### **Kent Terrace Cycleway**

**1. Traffic Modelling, Reporting and Calculations (Including SIDRA analysis) as it relates to the newly installed cycleway along Kent Terrace. To understand the predicted level of service decrease/increases for the following intersections:**

| Item | Document name/description      | Decision |
|------|--------------------------------|----------|
| 2    | Appendix 2 – Road Safety Audit | Released |

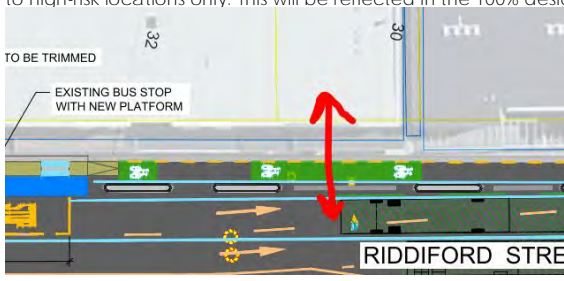
In reviewing the 90% Detailed design the SAT acknowledge that there has been an addition of green surfacing at conflict points, however, there remain locations where additional surface markings are required.

1. 32 Riddiford Street - off street parking accessway
2. Girton Tce – green dashed lines over intersection
3. Bus / cycle lane Riddiford Street right turn into Adelaide Road – dashed green line through on bus lane path to highlight special vehicle lane.

| Frequency                           | Severity   | Rating                         |
|-------------------------------------|--|--------------------------------|
| Designer response                   | <p>32 Riddiford Street access has green markings on drawings. No change proposed. Should be noted that Council have requested rationalisation of the green surfacing to high-risk locations only. This will be reflected in the 100% designs.</p>  <p>Cycle lane does not start till after Girton Terrace, as the area where cyclists will be travelling is a bus lane rather than a cycle lane there are issues with placing cycle</p> |                                |

|                         | Do not see safety benefit from marking green dashed continuity line through intersection, proposed signage (to be included with 100% design) and other markings sufficiently convey allowed movements from the left lane on Riddiford Street. No change proposed. |
| Action taken            | Update plans to reflect the green dashed continuity lines through John Street, Adelaide, Riddiford Street.  |

Figure 2-1: Riddiford Street southbound bus stop

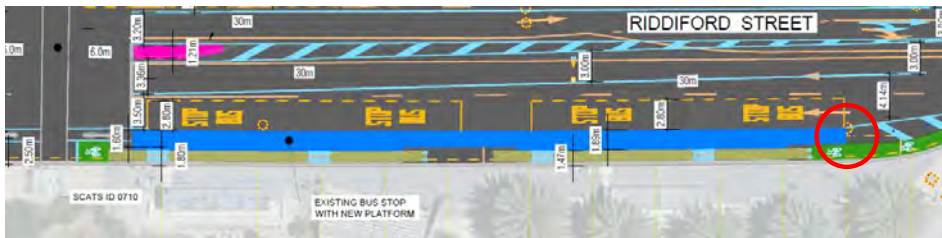
In reviewing the design, the SAT noted that the platforms are formed with square end raised ends (circled below). This will result in a vehicle / motorcyclist / cyclist snag point should an errant user impact with the end of the platform. For vehicles, the damage would be predominantly vehicle damage only, however for a motorcyclist and cyclist the injuries could be serious, with a resultant loss of control into the adjacent traffic lane and risk of impact from other traffic.

It is noted that the southbound lane leading into the bus stop is a general lane north of the hospital road intersection but is multiple bus stops following. This could cause late lane changes should a bus stop in the bus stop. It is acknowledged that as a general operation, buses will stop in traffic lanes to onboard / disembark passengers. Predominantly this occurs in the marked bus lane and should have little impact on the general user. In and around the hospital the stopping in the general traffic lane will have a greater impact.

| Designer response                                | Markings guide vehicles to avoid end of platform – no change proposed. |  |

|                         | Acknowledge risk identified by SAT, however, limited opportunity to mitigate in the limited space in advance of the intersection – no change proposed. |

Figure 2-5: Riddiford St / Adelaide Road / Johns Street

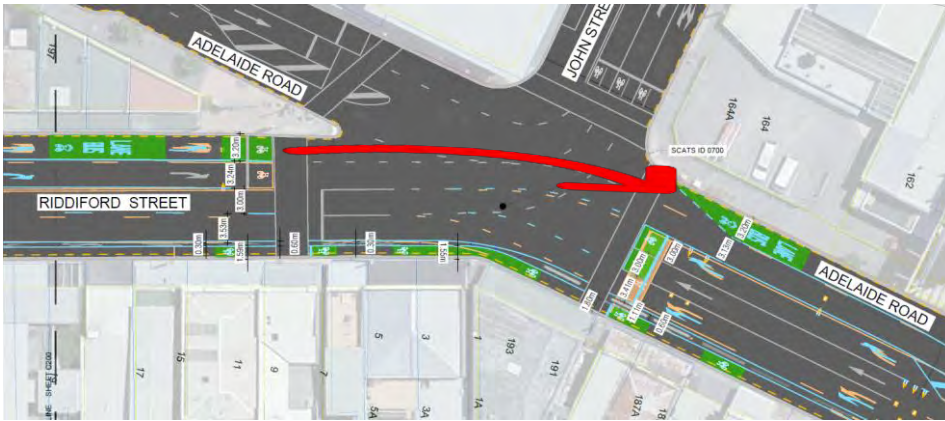
Cyclists northbound on Riddiford Street and continuing onward along Adelaide Road to the city will do so from the left-hand bus lane / cycle lane. The design incorporates an advance stop box to assist the cyclist as detailed in Figure 2-5 below.

The bus / cycle lane is marked in accordance with the two user classes; however, the lane markings (left turn arrow) would prohibit a through movement of both a bus and a cyclist unless an exemption is enabled. This has not been detailed.

| Frequency                       | Severity  | Rating                            |
|---------------------------------|---|-----------------------------------|
| Designer response               | As noted in response to 2.1.1 proposed signage (to be included with 100% design) and other markings sufficiently convey allowed movements from the left lane on Riddiford Street. No change proposed. |                                   |
| Safety Engineer comment         | Agree with SAT – signal information should be provided.<br><br>Key signalised intersections to be reviewed in <i>Safety in Design Workshops</i> .   |                                   |

Figure 2-9: Lane widths on Adelaide Road and width of separators

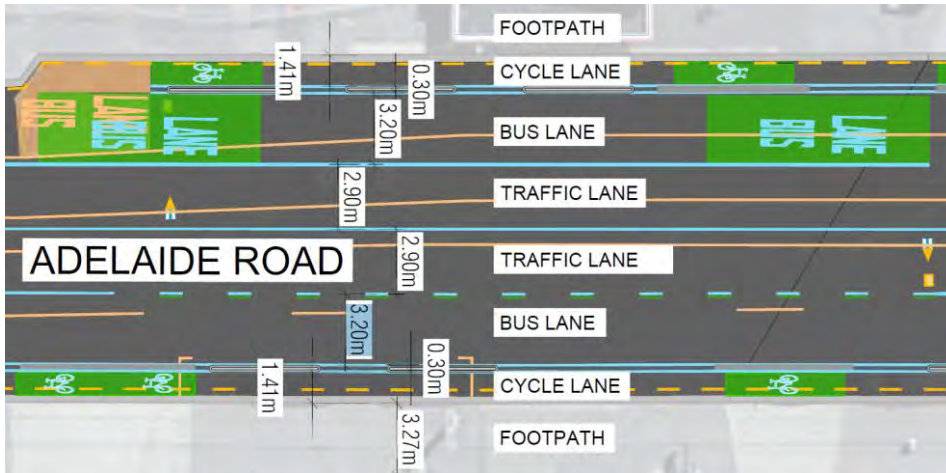
The road layout dimensions indicate that the physical separator is some 300 mm wide, with a 1.4 metre cycle facility alongside.

The SAT question the viability of a physical separator, especially of a temporary design for this width. It is acknowledged that some "stick-on" type separators closely match this width but would generally eliminate the capacity to install the detailed linework. The preferred separator should be of a size that deters people from driving over them.

1. Detail the specific separator type, and characteristics to ensure that sufficient deterrence is provided alongside the facility.

| Frequency                            | Severity  | Rating                         |
|--------------------------------------|---|--------------------------------|
| Designer response                    | Not a concern has physical separators are proposed.   |                                |
| Safety Engineer comment              | It is expected that the physical separators selected are fit for purpose and will deter vehicles driving over them. |                                |

Figure 2-10: Bus stop south of Broomhedge Street

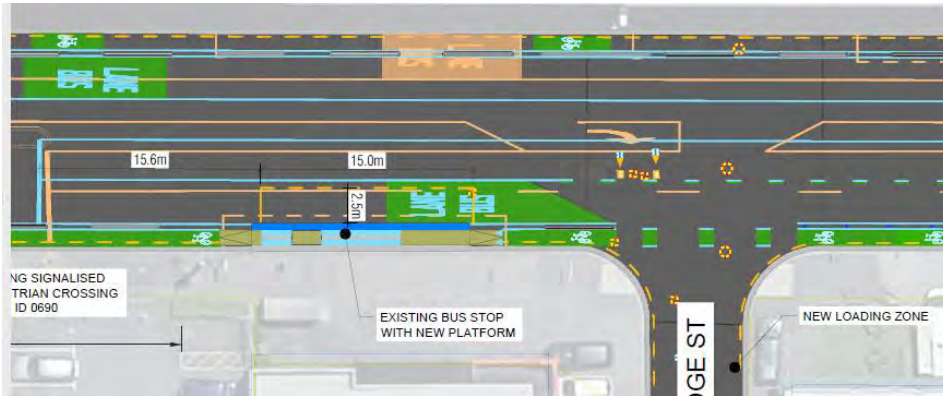
landing space provided is very narrow. No dimensions have been provided on the width of the bus platform, however when compared to the adjacent facility dimensions on the drawing set, it is assumed that the landing space is approximately 500 – 600 mm in width.

The narrow landing space would result in a passenger stepping from the bus directly into the path of a cyclist, with a risk of being clipped by passing cyclists.

1. Undertake a review of the bus platform design for the bus stops located at 101 and 110 Adelaide Road to provide a safe and appropriate landing zone for passengers alighting from the bus.
2. Provide a signs and markings drawing set for the controls required for cycle movement over the pedestrian facilities at bus stops
3. Install red pavement surface to all conflict zones as detailed in Section 2.1.2
4. Implement additional warning treatments into the design to assist Blind Low Vision users at these bus stops

| Frequency                           | Severity   | Rating                            |
|-------------------------------------|--|-----------------------------------|
| Designer response                   | <p>Council have purchased an off the shelf product which includes coloured components to highlight risk areas as shown below. The intention of the proposed layout shown below is to try and be as consistent as possible with previous treatments around Wellington city including Victoria Street.</p> <p>The 100% designs will include a signs and marking drawing. Signage for cyclists at bus stop conflicts will be provided where passengers will be alighting directly into the cycle path as per below.</p> |                                   |

| <p>Safety Engineer comment</p> | <p>Agree with Designer.</p> <p>The bus platform/cycle product and layout must be monitored and modified if necessary.</p>   |

Figure 2-11: Adelaide Road between Alfred St and Girton Tce – parking with adjacent bus lane

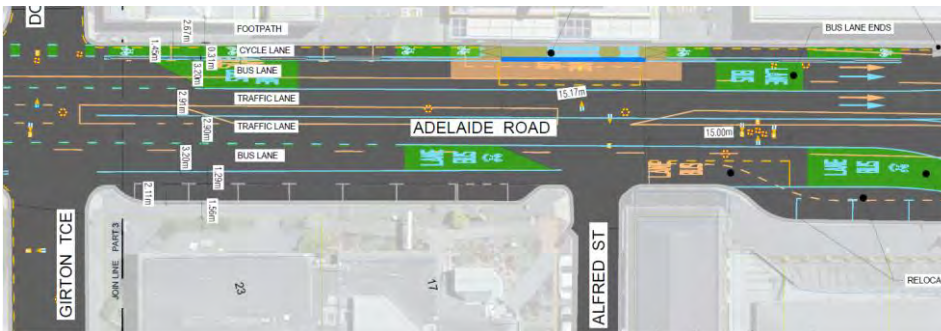
The design proposed has kerbside parking alongside the road shoulder between Alfred Street and Girton Terrace. Alongside this is an unmarked buffer, then the bus lane, as shown in Figure 2-11 below.

The supplied design drawings indicate that there are no side road control markings to define the hold point for Girton Tce. A review of previous site photos, and the aerial plans indicate that there is a current Give Way control. The SAT have assumed that the lack of side road control details is a draughting error, and that the current control will remain.

| Frequency                           | Severity   | Rating                            |
|-------------------------------------|--|-----------------------------------|
| Designer response                   | Agree – drawings should reflect current give-way controls remain.<br>Dashed green markings concern previously identified in section 2.1.1 – refer previous response. |                                   |

Figure 2-12: Adelaide Road / Rugby Street Intersection

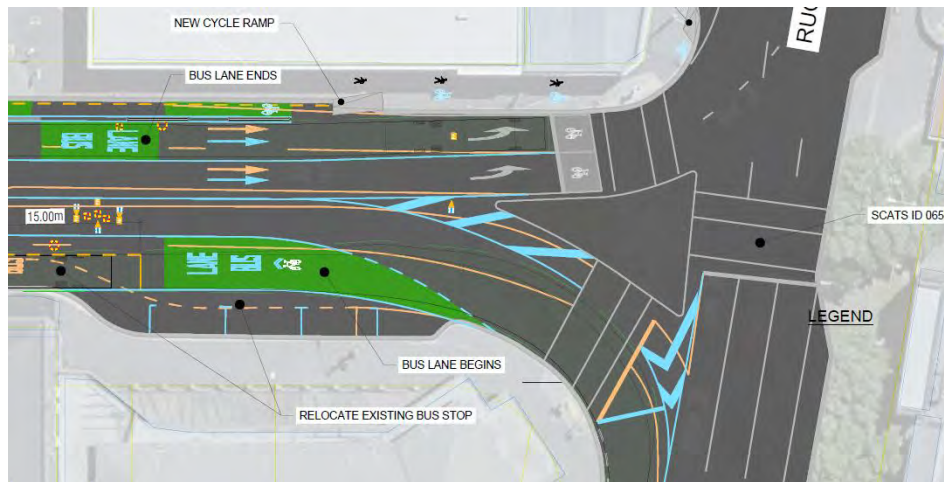
The SAT acknowledge the changes to the lane entry from Rugby Street into Adelaide Road and the inclusion of enlarged advance flush median chevrons, as detailed in Figure 2-12 below.

The tracking path for the bus has been supplied and demonstrates that the bus left turn can be accommodated within the provided lane. The SAT commend the solution provided.

1. There are no details to the configuration of the central splitter island. The SAT have assumed that there is no change to this arrangement. The SAT comment that the improved cycle facility along this route may result in the general increase in number of cyclists, resulting in a congested wait area.

5. A flush median is shown on the plans at the location of the splitter island. The SAT comment that this could be supported through the use of vertical bollards to reinforce the slow nature of the turn, provide additional stack space and shorten the crossing distance. This further reduces the risk of a driver undertaking a late turn / passing movement using the flush median.

| Frequency<br>Crashes are likely to be occasional | Severity<br>Death or serious injury is likely  | Rating<br>The safety concern is moderate |
|--|--|--|
| Designer response                                | No change to function central splitter island – no change proposed. Agree that as demand increases the current facilities may become congested this should be considered as part of permanent changes along this corridor.<br>Agree with SAT.<br>Agree with SAT – vertical delineators should be included in the flush median! |  |

Figure 2-13: Cambridge Terrace southern end of cycle lanes.

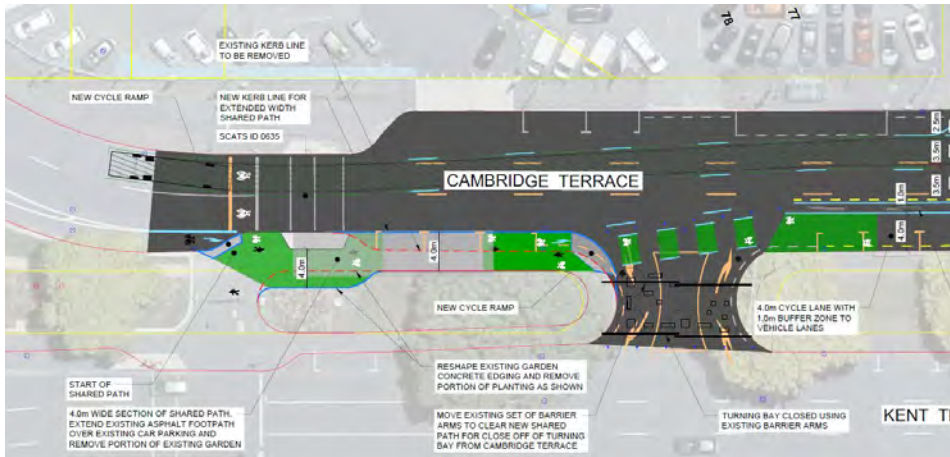
The SAT note the intended start position of the new facilities on Cambridge Terrace, exiting from the Basin Reserve area. Refer to Figure 2-13 below.

The SAT note that for the southbound movement (towards Basin Reserve), there is no guidance into a suitable facility, which could lead to cyclists in conflict with other footpath users either on the central path, or on the footpath on the Kent Terrace side.

The impact of a cyclist with vulnerable users such as the elderly and blind low vision people could result in higher severity injuries. As detailed, the elderly generally has a lower capacity to recover from high trauma injuries, with the resulting injury severity being serious.

| Frequency                           | Severity   | Rating                         |
|-------------------------------------|--|--------------------------------|
| Designer response                   | Agree with SAT   |                                |
| Safety Engineer comment             | <p>Agree with SAT.</p> <p>Detail on cycle lane continuity through or around the Basin has not been provided.</p> <p>Although there have been general discussions on way-finding through the Basin, or around the Basin during an event, the absence of acceptable plans and detail continue to pose a moderate to significant risk. These should be included in the final package for overall approval of this cycleway.</p> |                                |

Figure 2-14: Typical U-Turn closure detail

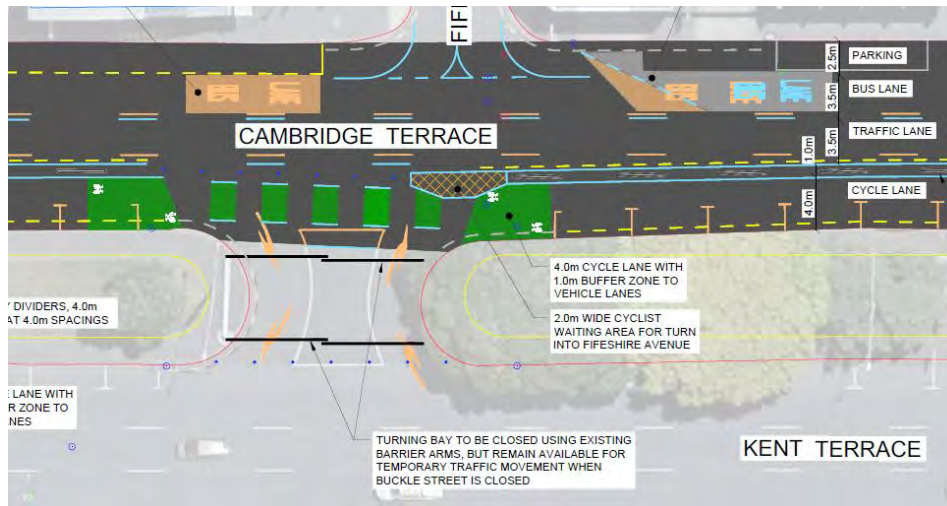
The SAT recognise the design has sought to temporarily close the current U-Turn pockets along Cambridge Terrace / Kent Tce. A typical closure detail is shown in Figure 2-14 below.

The use of vertical bollards will initially be effective due to their clean and new visible nature, however over time they will typically degrade and become ineffective. The vehicle movement alongside the bollards will result in wheel splash and covering in road grime. The SAT comment that a high level of maintenance intervention will be required to ensure that the bollards are fit for purpose and remain effective.

1. The design does not detail the effects on the greater network with the closure of the U-Turn pockets in place. The SAT comment that the removal of all U-Turn pockets south of Elizabeth Street may result in adverse turn movements at Vivian Street. The SAT recognise that the closure of the U-Turn pockets will require drivers to traverse around the Basin Reserve or Elizabeth Street to access business / streets on the opposite side of the central median.

1. That ROAD CLOSED / NO ENTRY / NO RIGHT TURN signs are installed on both sides of the central median, highlighting to drivers that the facility is closed.
2. That the bollards on the Kent Tce side are positioned such that safe pedestrian movement via kerb ramps is maintained when crossing over the U-Turn pocket.
3. That a high level of maintenance intervention of the closure bollards is applied on both a reactive and proactive manner.
4. That full retro-reflective material is applied to the barrier arms.
5. A detailed traffic management plan is developed early, that includes all actions, equipment and guidance required to address the change in priority for the U-Turn pocket.

| Frequency                           | Severity   | Rating                         |
|-------------------------------------|--|--------------------------------|
| Designer response                   | Agree with SAT – noting that some of these recommendations are already included in the design (e.g. item #2)/ and or currently exist (e.g. item #4). |                                |

Figure 2-15: Cambridge Tce and Fifeshire Ave intersection

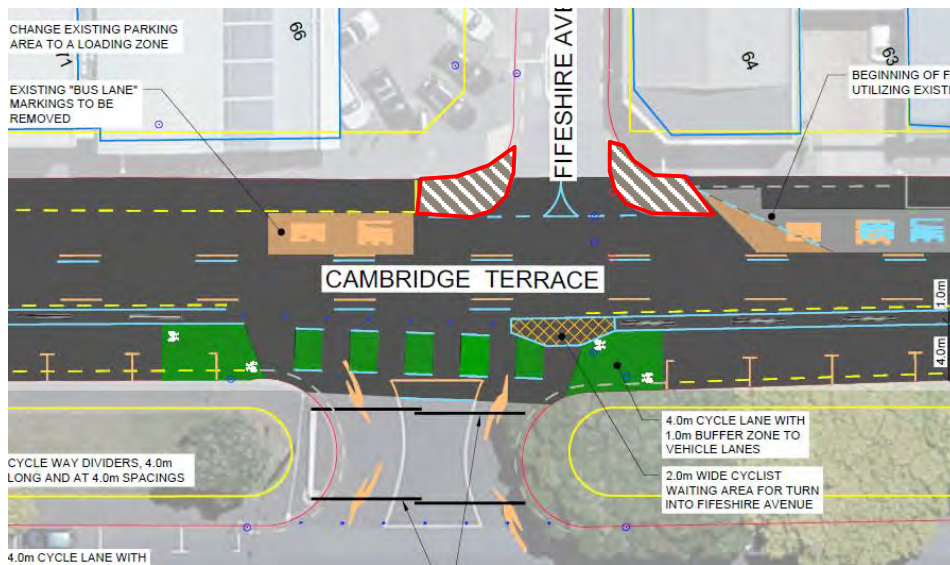
The SAT however do note that the design provides edge lines that commence on the traffic lane side of the loading zone, and turn into Fifeshire Ave, both sides. The current markings could be identified as a parking area. The SAT recommend that shoulder chevrons and no-stopping lines are installed to maintain the intervisibility sight line at the intersection (marked on Figure 2-15 above).

The revised design as presented in the 90% design drawings indicates that the kerb line (southbound, west side) has been adjusted to enable the passing of the bi-directional facility past the hook turn for Fifeshire Ave. The design fails to detail the provisions for pedestrians along the north / south route. The SAT note that with the closure of the U-Turn facilities, the central median route could become more attractive for pedestrian movement north and south as it eliminates the need to cross minor side roads.

| Frequency<br>Crashes are likely to be common | Severity<br>Death or serious injury is likely   | Rating<br>The safety concern is significant |
|--|---|---|
| Safety Engineer comment                      | Agree with Designer.  |   |

Figure 2-16: Cambridge Tce / Vivian Street intersection

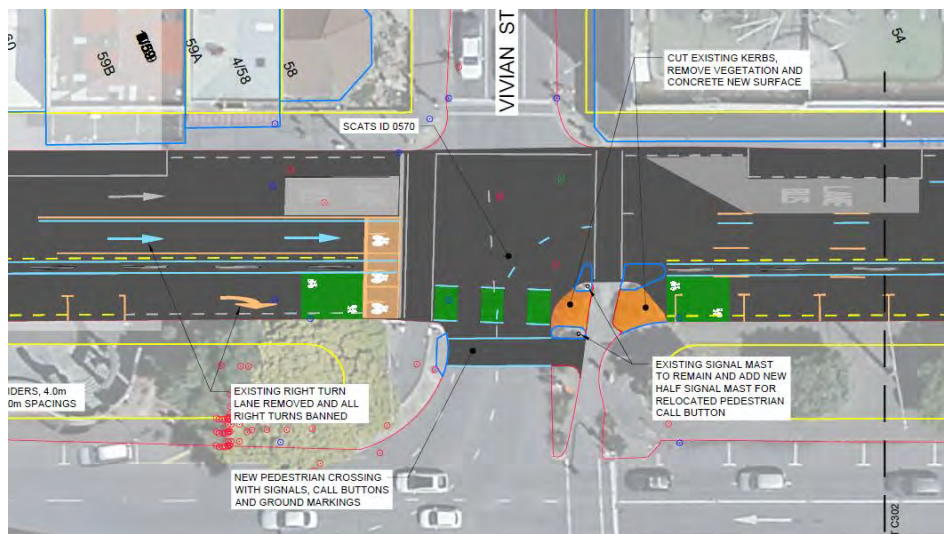
The cycle facility crosses over the pedestrian movement north of the Vivian Street intersection. This crossing does not indicate who has priority – pedestrian or cyclists. The pedestrian will be waiting at the edge of the crossing on the Cambridge Tce side, and depending on user and numbers, would result in pedestrians straying across the cycle path. The SAT recommend that pedestrian crossing bars, with all signs and markings being installed. This crossing requires tactile pavers for the pedestrian movement over the cycle facility.

The SAT consider that given the risk of the pedestrian / cycle conflicts, it is imperative that red pavement markings are installed at the conflict zone.

| Frequency                       | Severity  | Rating                            |
|---------------------------------|---|-----------------------------------|
| Designer response               | Agree with SAT – signal information should be provided.                             |                                   |

Figure 2-17: Cambridge Tce turning pockets for cyclists

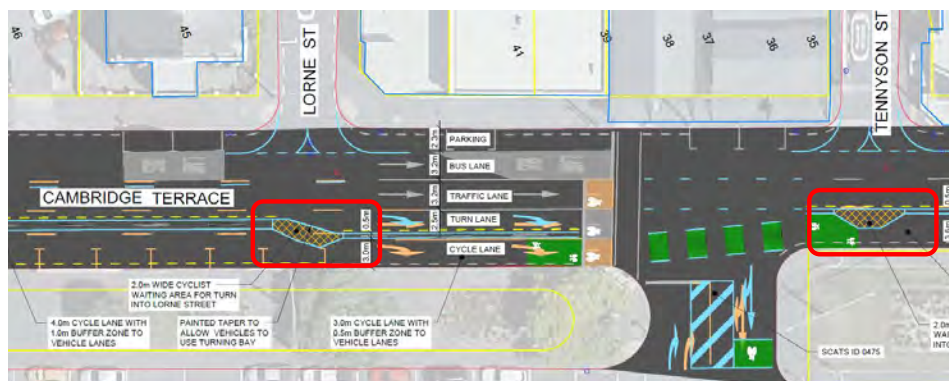
The design details a hatched zone for the provision of the turn movement into, and out of Lorne Street. This design narrows the cycle markings for the through movement at this location and occurs at the development of the right turn lane.

The hatched zone will be required to accommodate cyclists who not only turn in, but also turn out of Lorne Street and Tennyson Street. The SAT are of the opinion that the marked space is insufficient to allow cyclists to safely depart from the through movement, or wait safely to join the through movement, without their wheel being exposed to passing traffic. This waiting space impedes on the safe movement of cyclists along the bi-directional facility. The SAT acknowledge that the cycle turn volume at these locations may be low, however the risk remains.

Figure 2-19: Cycle Path transition through Courtenay Place / Majoribanks St intersection to Oriental Parade

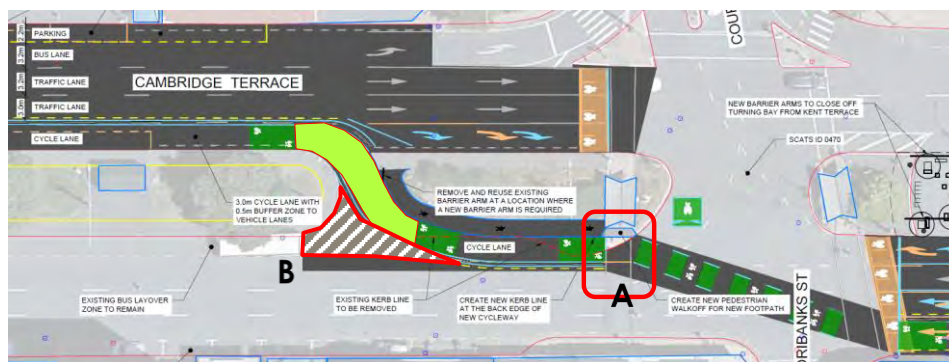
The commencement of the movement to the new route on the east side of Oriental Parade is characterised by a chicane movement from the west side of the central median, through to a cross-over facility over the Courtenay Place intersection, then along the east side of Oriental Parade.

In reviewing this new design, the SAT have considered the interaction between bi-directional cyclists, and pedestrian movements at the chicane. The design currently has minimal green marking on the new cycle lane surface, especially in the path of the pedestrian movement.

In addition to the green markings, it is noted that there appears to be no detail on the required hold lines and signal aspects for the north / south movement. Refer to position A on Figure 2-19 above.

The current design creates an area alongside the cycle facility where a driver could consider that there is a parking space (despite the markings) and artificially creates a wider road aspect. Refer to position B on Figure 2-19 above.

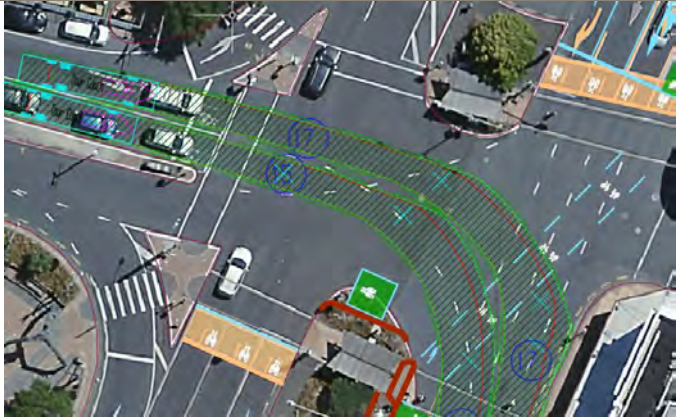
- ⌘ Southbound cyclists do not appear to have a signal aspect and hold position identified in the design for the movement. This includes all markings and signs for guidance.

- ⌘ It would be unsafe for a cyclist to drop from the separated cycle facility and cross multiple lanes to access Courtenay Place

1. Undertake a significant redesign of the facility, considering the safe movement of cyclists to and from Courtenay Place.

Figure 3-1: Alternate cyclist linkage to/from Courtenay Place

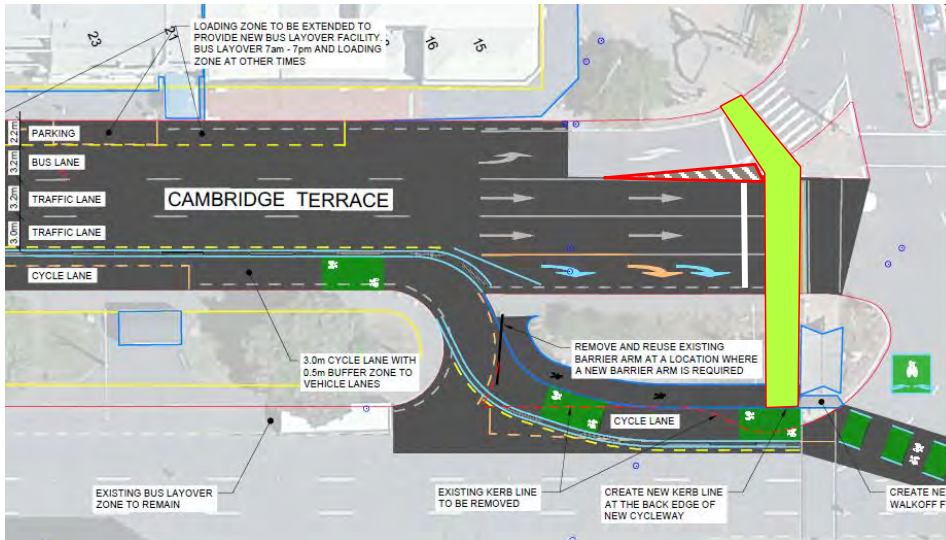
The current pedestrian crossing south of the intersection has a suitable level of service for pedestrians, however this would not be suitable to incorporate cyclists as part of the crossing movement on the current crossing point. Access to the existing path through the central median also occurs immediately adjacent to the lane shift of the new facility.

The SAT consider that there is a possible alternate linkage for cyclists from the new bi-directional facility, through the central island and across into Courtenay Place, running parallel with the current facility, as indicated in Figure 3-1 above.

This could be achieved through the formation of a new path through the central median, with porous pavers over the garden to maintain tree health. The limit line of the northbound movement can be moved back to facilitate the inclusion of a new crossing feature, ASB for through movements, and inclusion of a longer splitter island.
